630 E Washington Ave - Salvation Army Dane County  
Project No.: 13993 Contract No.: 9137  
Entity: The Salvation Army Services, Inc.

**Site Plan**  
622 and 630 East Washington  
City of Madison  
Dane County, Wisconsin

**ADDENDUM NO. 1**

**CONTRACT FOR THE CONSTRUCTION OF PUBLIC IMPROVEMENTS  
TO BE ACCEPTED BY THE CITY OF MADISON  
630 E WASHINGTON AVE – SALVATION ARMY DANE COUNTY  
CONTRACT NO. 9137  
PROJECT NO. 13993**

DWG. NO.: C2.2

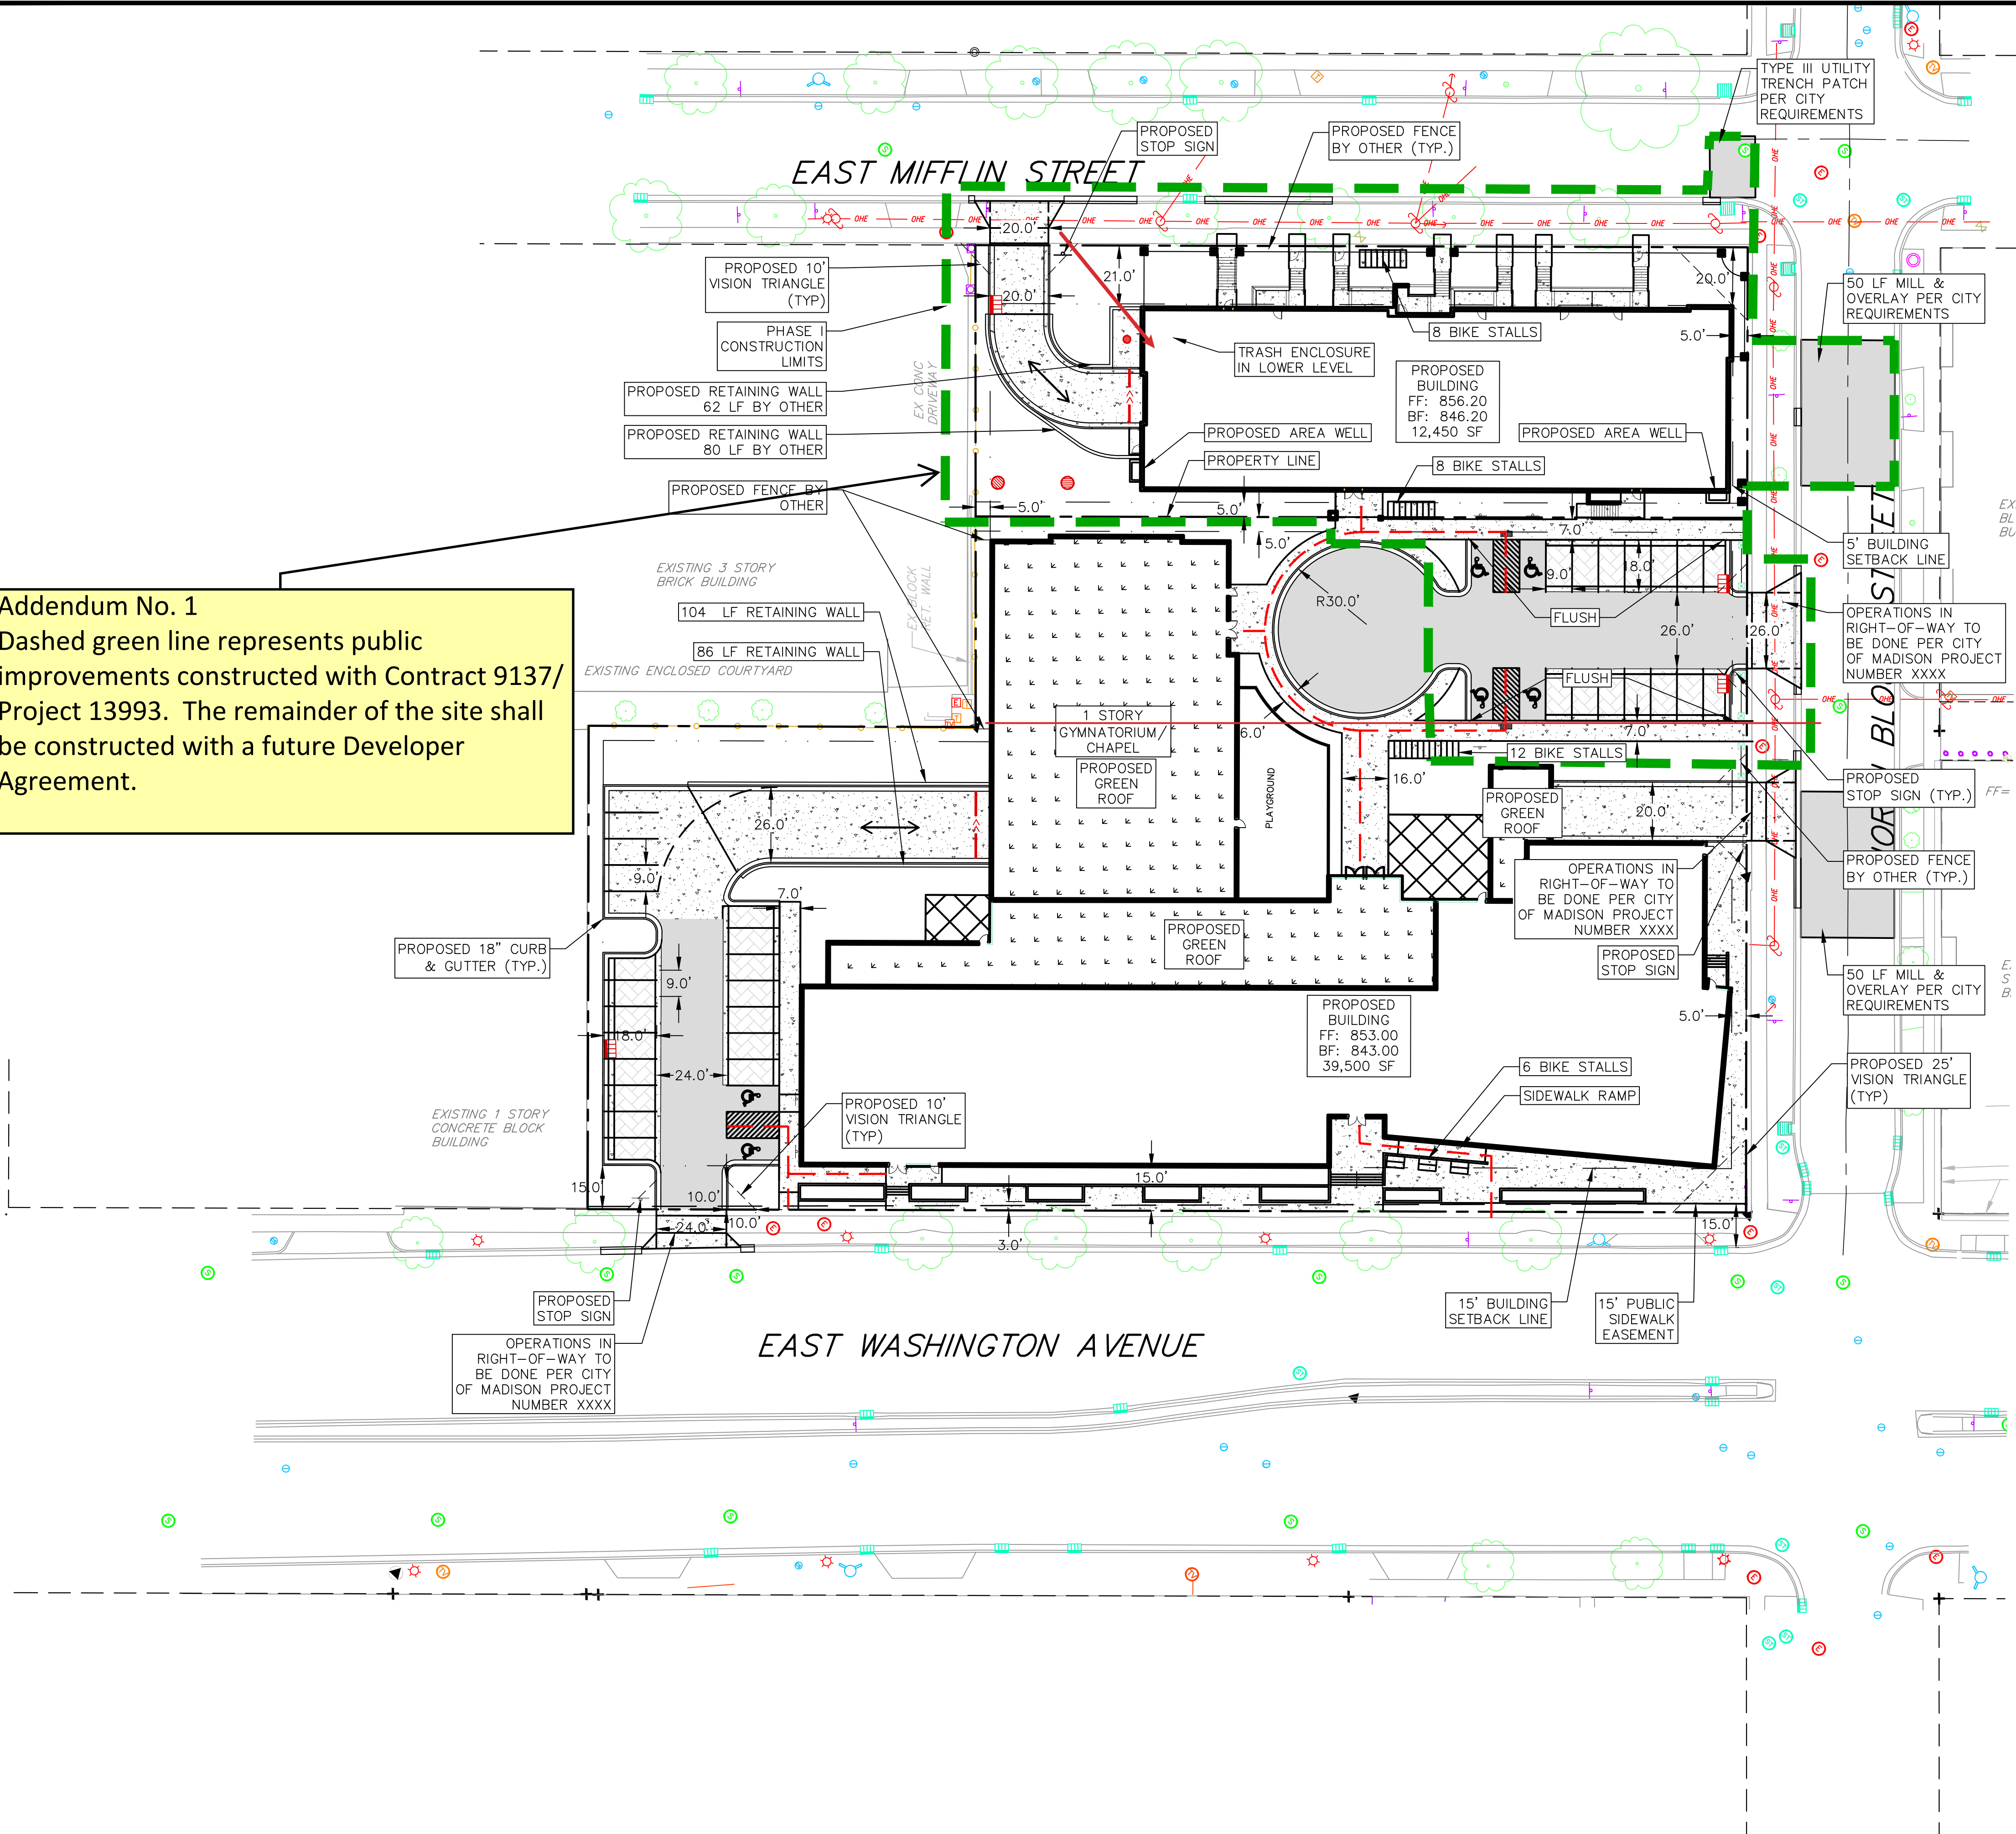
**Addendum No. 1**  
Dashed green line represents public improvements constructed with Contract 9137/Project 13993. The remainder of the site shall be constructed with a future Developer Agreement.
